# SERVICE LETTER

**SUBJECT: PRATT & WHITNEY CANADA SERVICE BULLETIN  
NO: 14230 (AUG. 15/95).**

**Annex A to Pilatus Service Letter PC-12 No: 005**

TURBOPROP ENGINE  
FUEL CONTROL UNIT (FCU) - MODIFICATION OF

Progression of the Fuel Control Unit (FCU)  
Figure 1

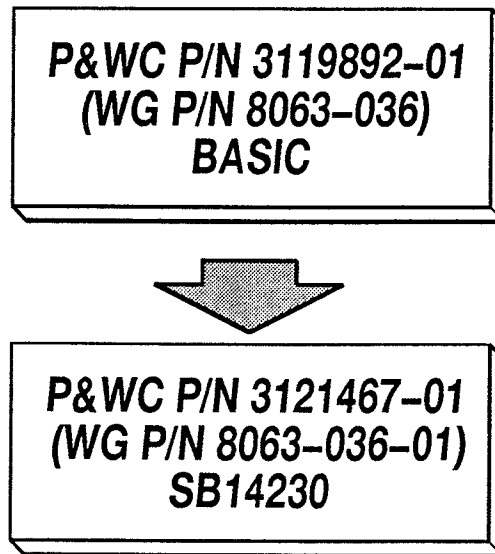
A. A modification can be done to the existing serviceable Fuel Control Units (FCU)  
P&WC P/N 3119892-01:

A. Refer to Figure 1 for the parts progression of the Fuel Control Unit (FCU).

You can make a modification to the OLD P/N and identify it to the NEW P/N (Ref. Accomplishment Instructions):

WG P/N 8063-036  
(P&WC P/N 3119892-01)

WG P/N 8063-036-01  
(P&WC P/N 3121467-01)
